RHODE ISLAND DEPARTMENT OF TRANSPORTATION

RHODE ISLAND CONTRACT NO.2016-CB-064

**0031N OLD SAKONNET RIVER BRIDGE DEMOLITION**

ADDENDUM NO. 1 Prospective bidders and all concerned are hereby notified of the following changes in the Plans, Specifications, Proposal and Distribution of Quantities for this contract. These changes shall be incorporated in the Plans, Specifications, Proposal and Distribution of Quantities, and shall become an integral part of the Contract Documents.

SHEET DESIGNATION: **G-4**

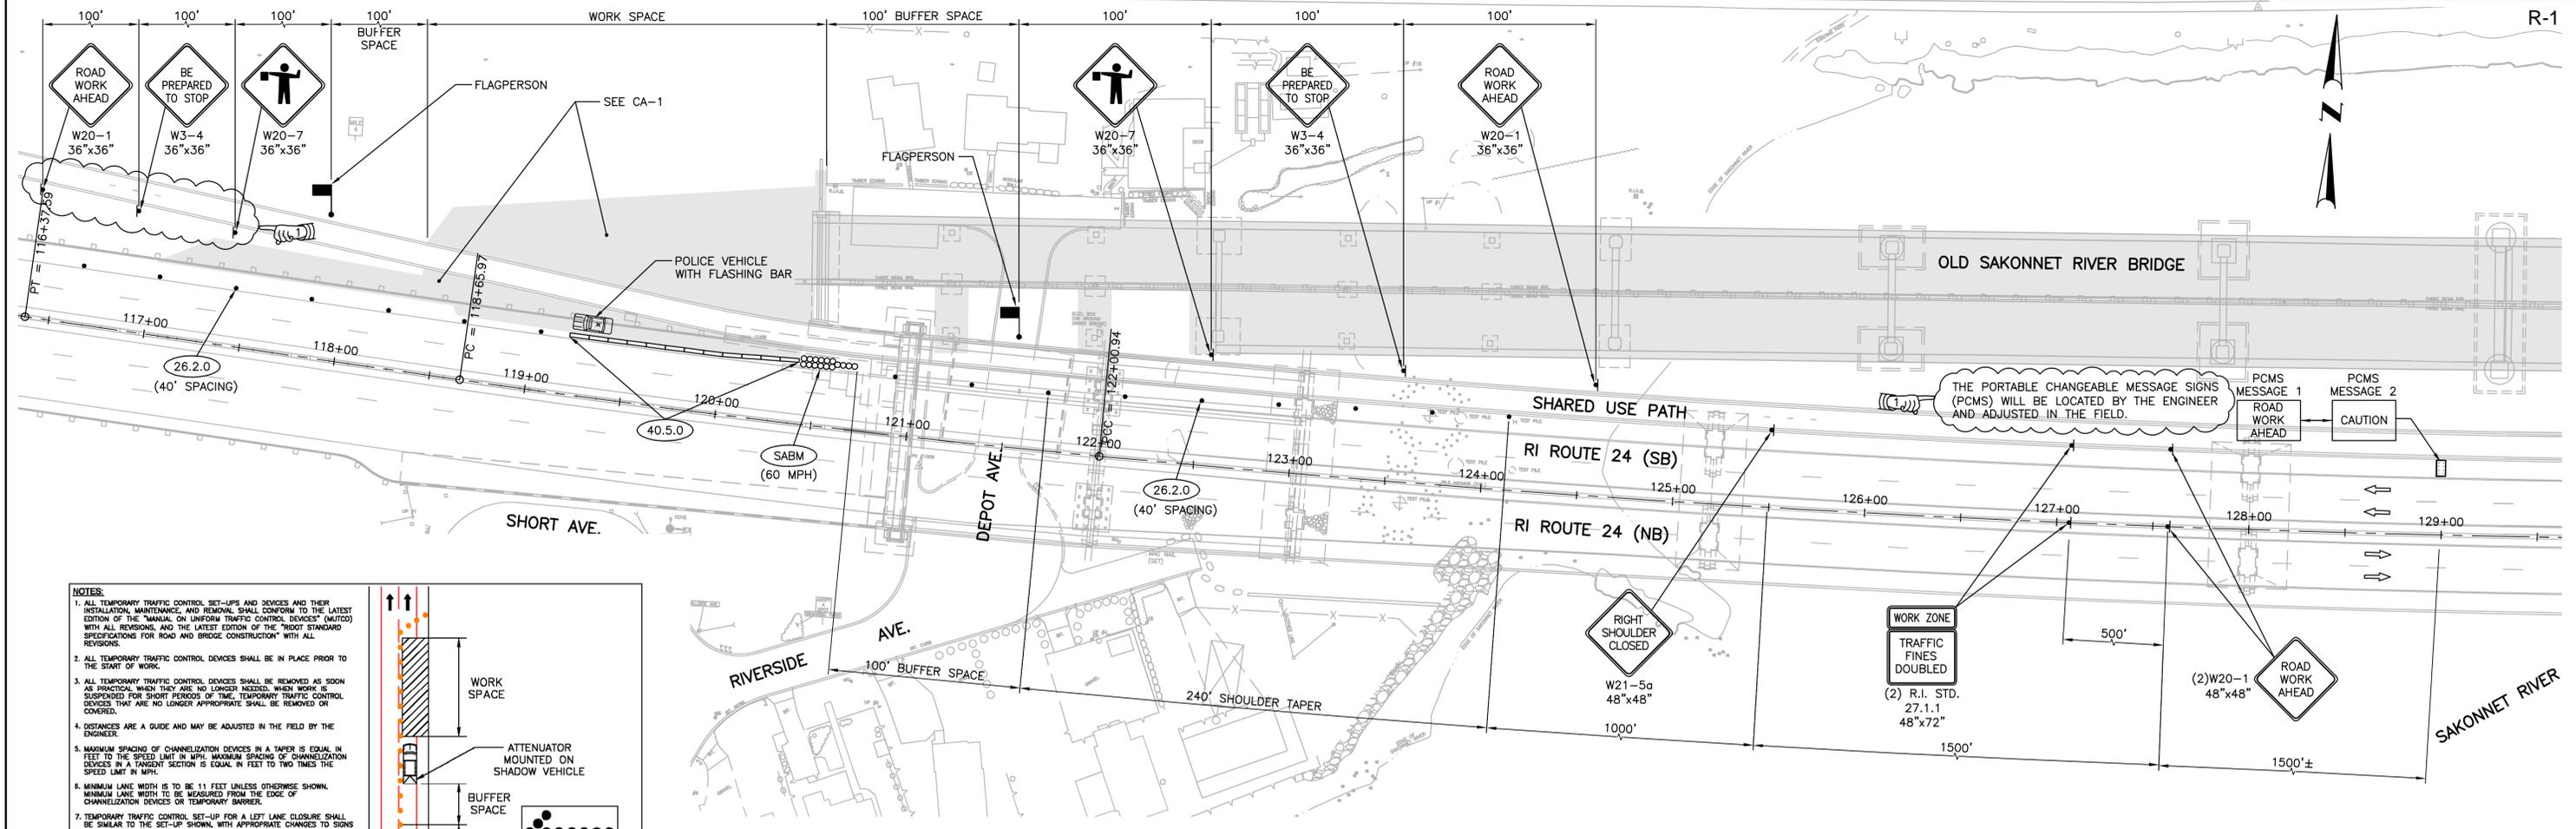
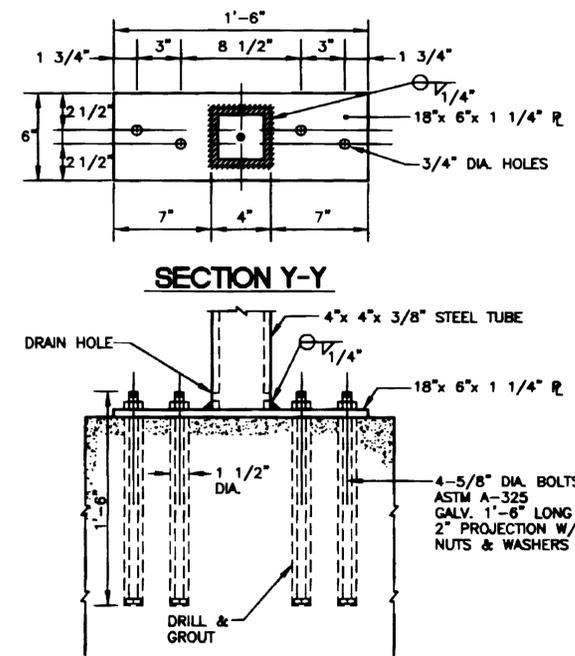
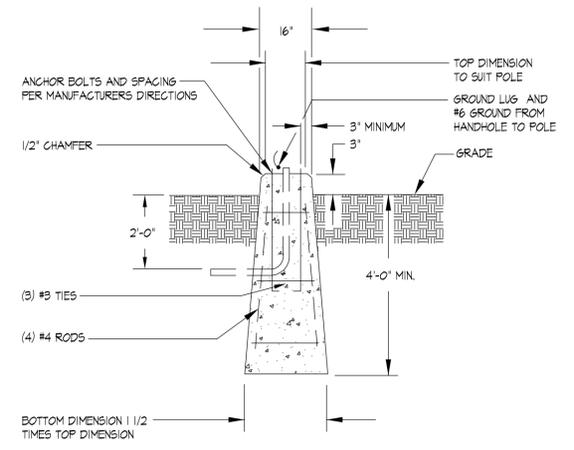
1. Sheet 5 of 30

Remove Sheet 5 in its entirety and replace it with revised Sheet 5 (R-1) attached to this Addendum No. 1. The Job Specific Plan Symbols, Legend & Notes have been revised.

SHEET DESIGNATION  
**MPT-1**

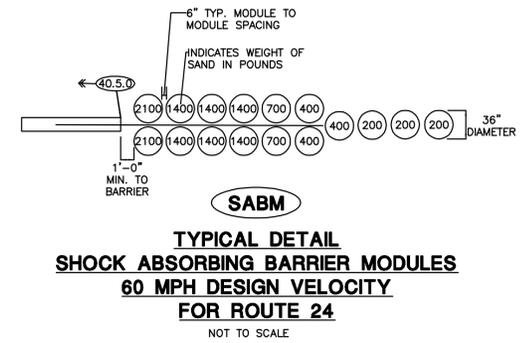
2. Sheet 25 of 30

Remove Sheet 25 in its entirety and replace it with revised Sheet 25 (R-1) attached to this Addendum No. 1. The Maintenance and Protection of Traffic Notes and PCMS Note have been revised. The temporary signs on the Shared Use Path have been moved to the other side of the path.
